Subject: SUBJECT: CASE#5-VEN-16-0046....320 SUNSET AVE, VENICE -- UPHOLD THE APPEAL

W30a

ADDENDUM

A-5-VEN-16-0059 (Fran Camaj) Appeal – Substantial Issue and De Novo Page 26

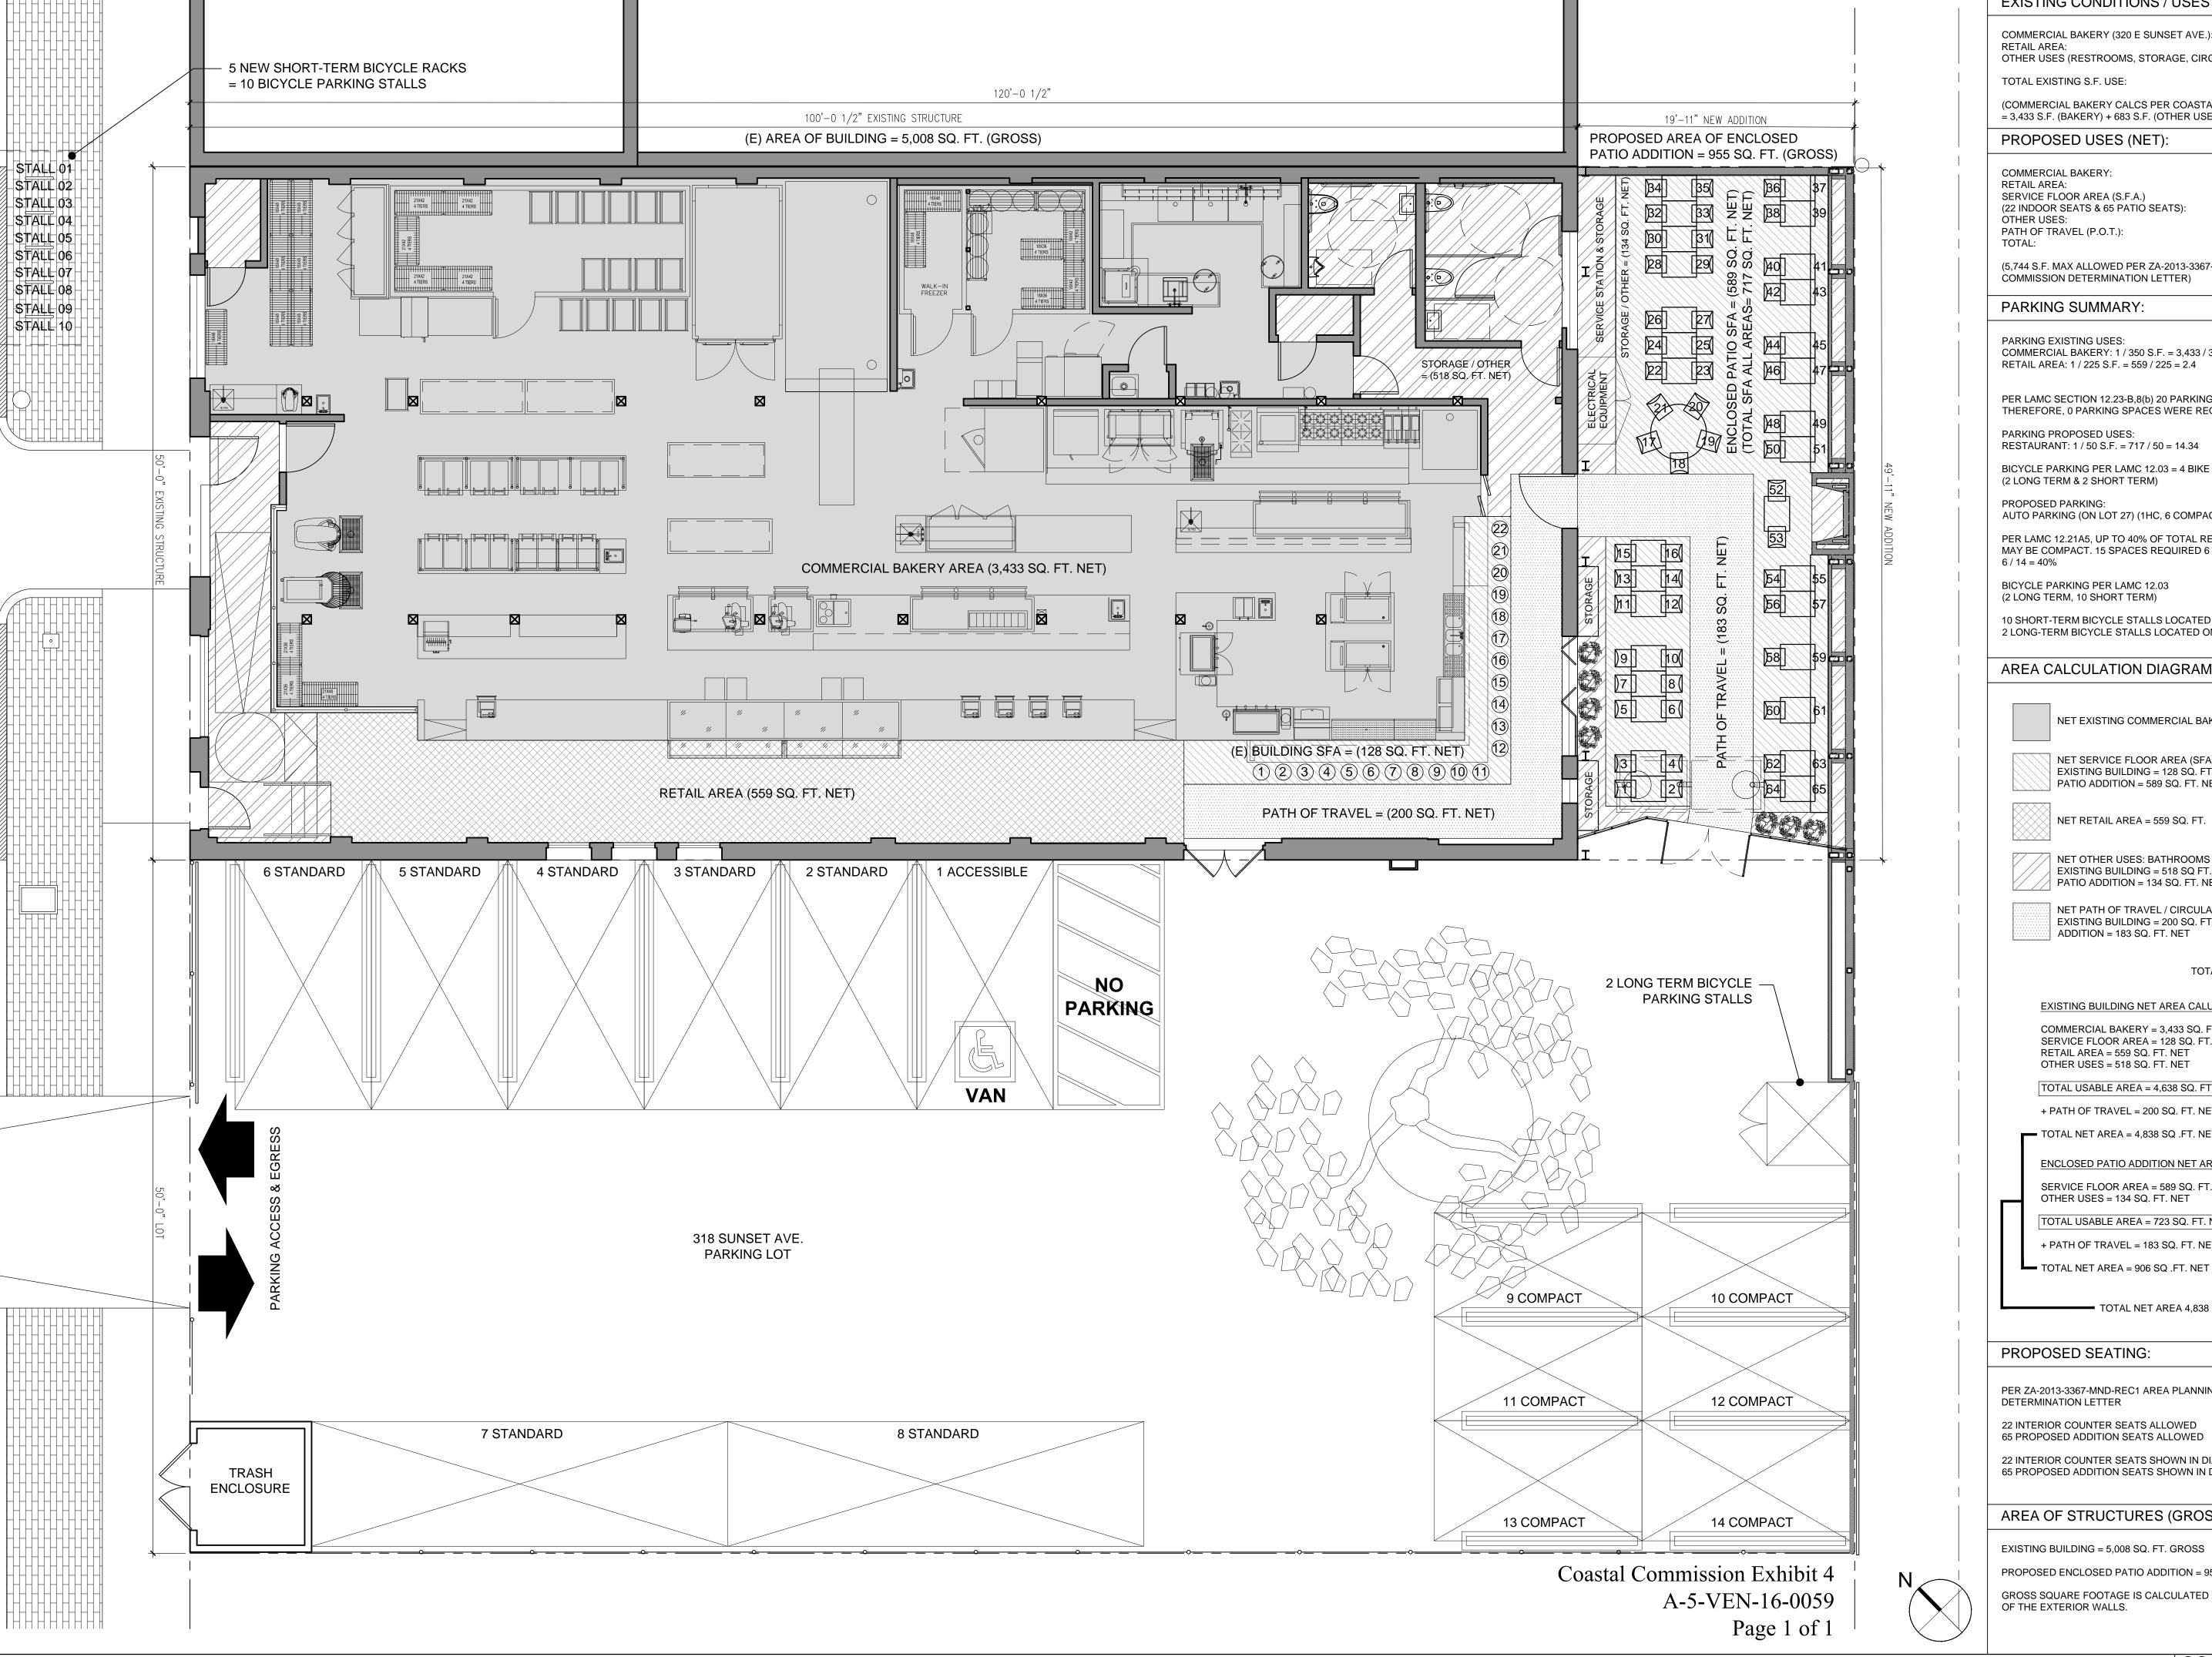
In reference to the layout presented in Sheet A1.1, the issues are:

In reference to the layout presented in Sheet A1.2, the issues are:
